Illinois Tollway Base Sheet Revisions			
Section M	Base Sheet Drawings		
	Drawing	Modification Summary	Effective: 03-31-2016
	All	The electronic (pdf) version of the Standard Drawing are now made searchable (text).	
Erosion Sediment Control (ESC)-Series 200			
M-ESC-205	Sediment Basin Dewatering Device		
	Revised Note 7, removed proprietary name from skimmer device.		
Roadway (RDY)-Series 400			
M-RDY-408	Approach Slab, Mainline		
All	Changed Transverse Reinforcement size and spacing in the bottom mat of the bridge approach slab and transition approach shoulder slabs from #6@9" to #8@4" to be in conformance with IDOT ABD Memo 15.8.		
All	Changed Transverse Reinforcement size and spacing in the top mat of the bridge approach slab and transition approach shoulder slabs from #5@12" to #5@6" to be in conformance with IDOT ABD Memo 15.8.		
All	Changed Longitudinal Reinforcement size and spacing in the top mat of the bridge approach slab and transition approach shoulder slabs from #4@15" to #5@6" to be in conformance with IDOT ABD Memo 15.8.

Tollway Base Sheet Revisions		
Section M	Base Sheet Drawings	
	Drawing	Modification Summary Effective: 03-31-2016
	Maintenance of Traffic (MOT)-Ser

OUTLET CONTROL STRUCTURE
CHECK DAM DETAILS

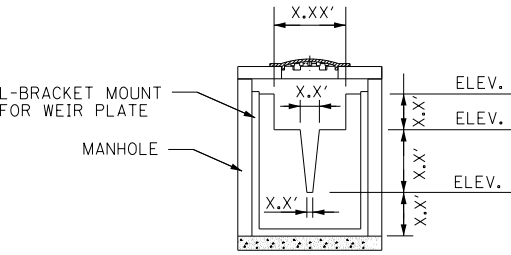
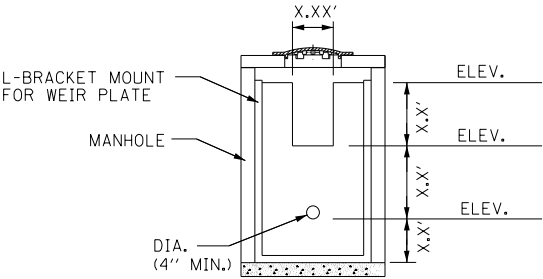
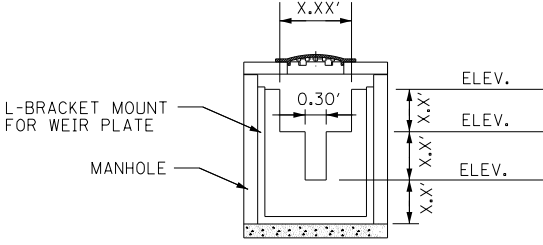
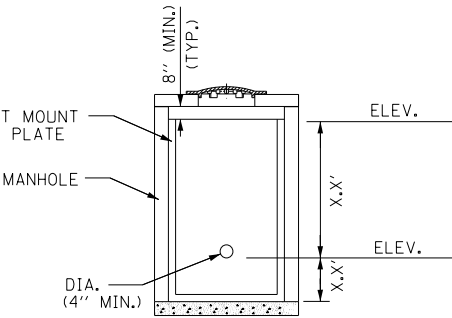
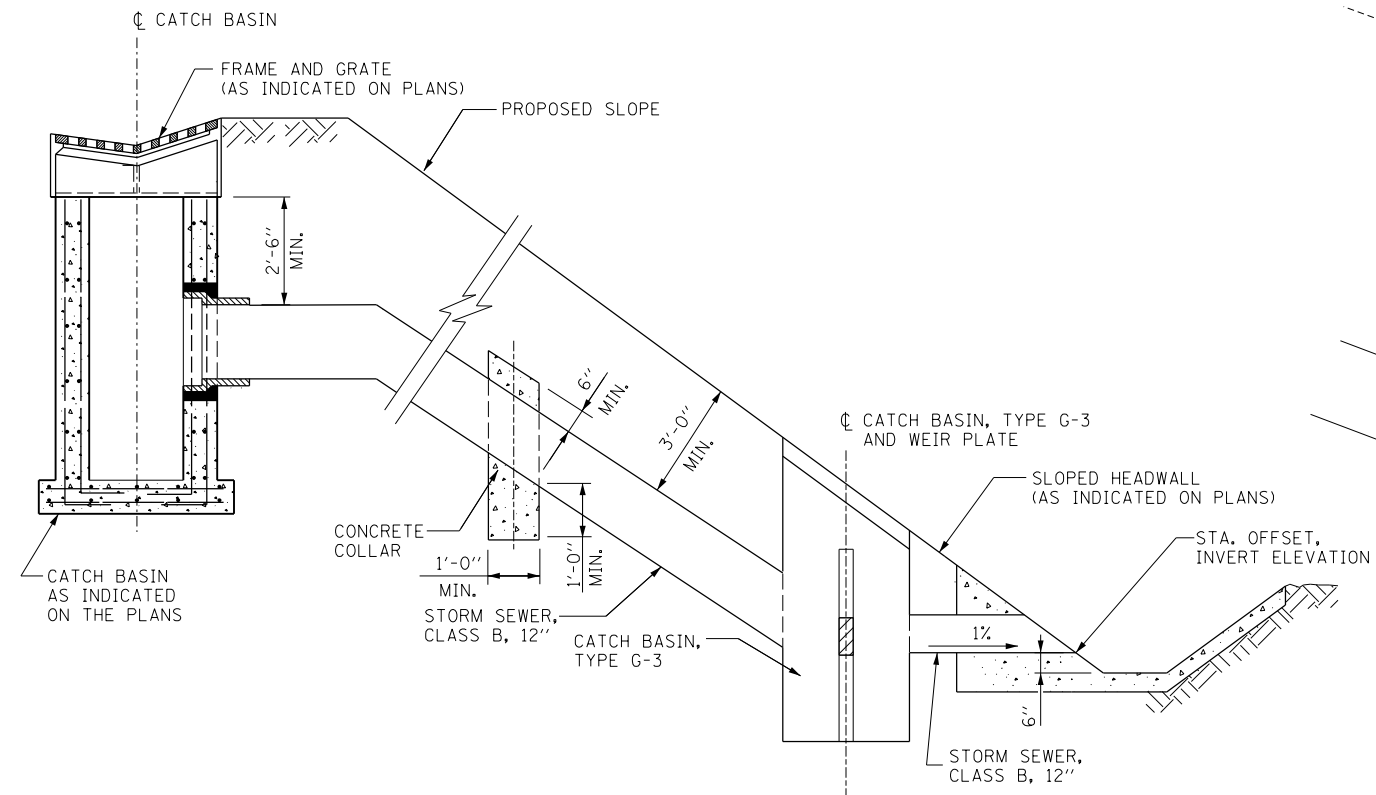
New Sheet

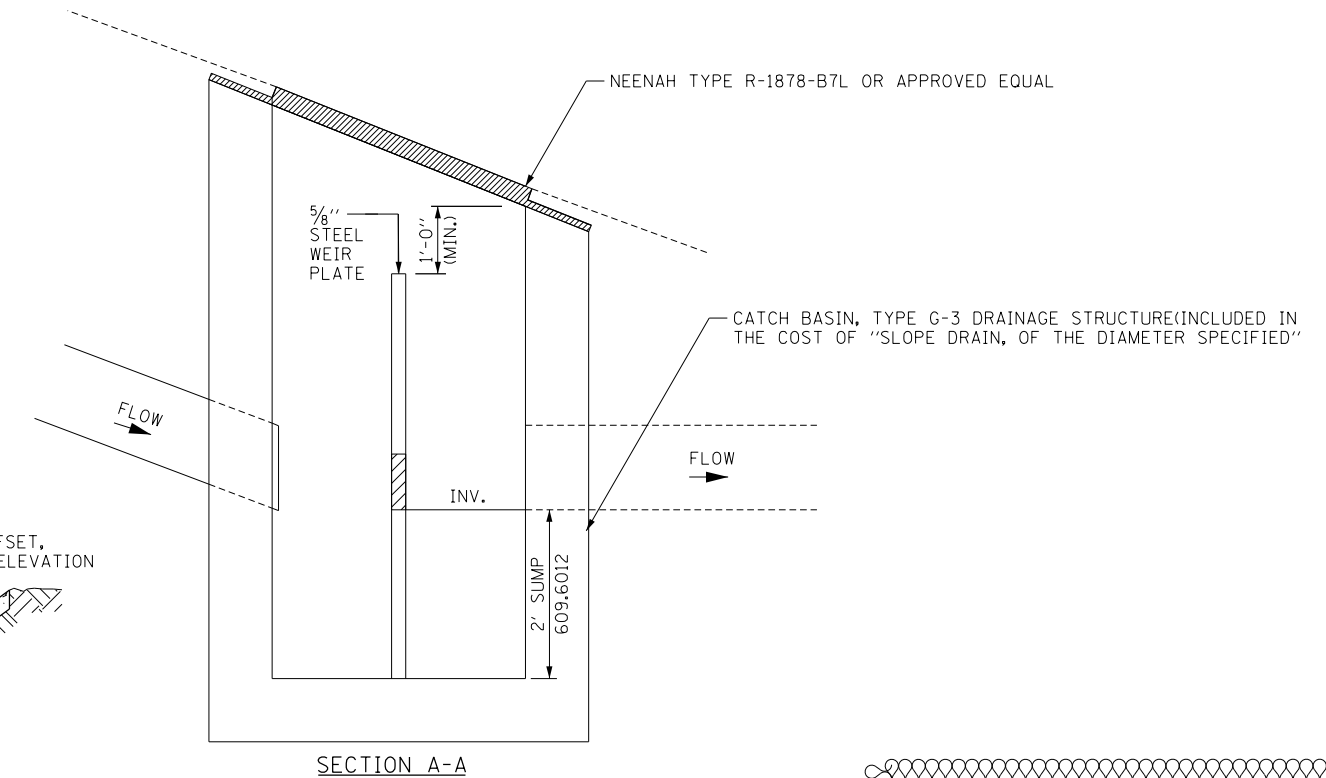
Sheet 5	Revised Bill of Material to clarify Pay Items and Pay Item Numbers to be included.		
Sheet 5	Added note to Typical Barrier Transition Detail to clarify where the 1'-9" dimension should be measured.		
M-RDY-410	Reserved		
M-RDY-411	Emergency Turnaround Median Width ≥ 35 Ft		
Bridge (BRG)-Series 500			
M-BRG-506	Expansion Joint Repair		
	Base Sheet was removed since details did not match Special Provision.		
M-BRG-507	Crash Wall Modifications Median Piers		
	Note 4 - Changed Reinforcing bars to Reinforcement Bars.		
M-BRG-508	Crash Wall Modifications Shoulder Piers		
	Note 4 - Changed Reinforcing bars to Reinforcement Bars.		
M-BRG-525	Slopedwall Details		
Drainage (DRN)-Series 600			
M-DRN-601	Slope Drain		
	Revised storm sewer to "Class B, 12".		
M-DRN-602	Bioswale

1. THE STORM SEWER, CONCRETE COLLAR CATCH BASIN, TYPE G-3, WEIR PLATE AND FRAME, AND GRATE, SHALL BE INCLUDED IN THE COST OF SLOPE DRAIN OF THE DIAMETER SPECIFIED.
2. SEE ILLINOIS TOLLWAY STANDARD B8 FOR DIMENSION OF CATCH BASIN, TYPE G-3 STRUCTURE.
3. THE TOP OF THE CATCH BASIN, TYPE G-3 SHALL BE CUT IN THE FIELD TO MATCH THE PROPOSED EMBANKMENT SLOPE.
4. THE CONTRACTOR HAS THE OPTION TO USE A CONCRETE RESTRICTOR PLATE THAT IS PRECAST WITHIN THE DRAINAGE STRUCTURE.
